SUGARING NYC

20212 EVA STREET MONTGOMERY, TEXAS SUITE 130

- A-0.0 COVER
- A-0.1 LIFE SAFETY PLAN
- A-1 FLOOR PLAN
- A-2 ELECTRICAL & TELE./DATA LAYOUT
- A-3 REFLECTED CEILING PLAN
- A-4 SCHEDULES AND DETAILS
- A-5 GENERAL NOTES
- A-6 INTERIOR ELEVATIONS
- A-7 ACCESSIBLE DETAILS

12/06/22
CORRECT MEP PLANS AND RESUBMIT

Mechanical Floor Plan 3/16" = 1'-0"

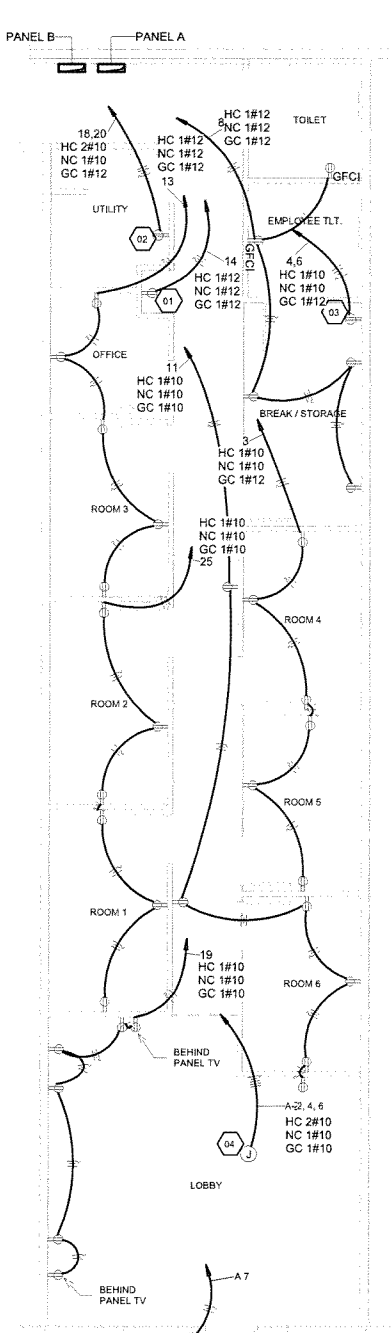
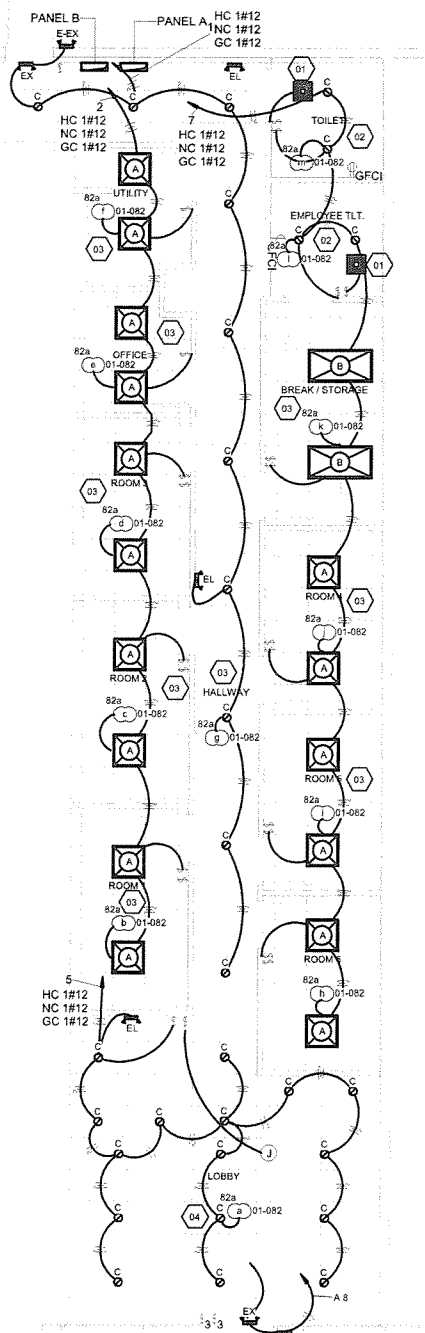
relocate RTU
see attached bldg roof
plan for equipment
zones
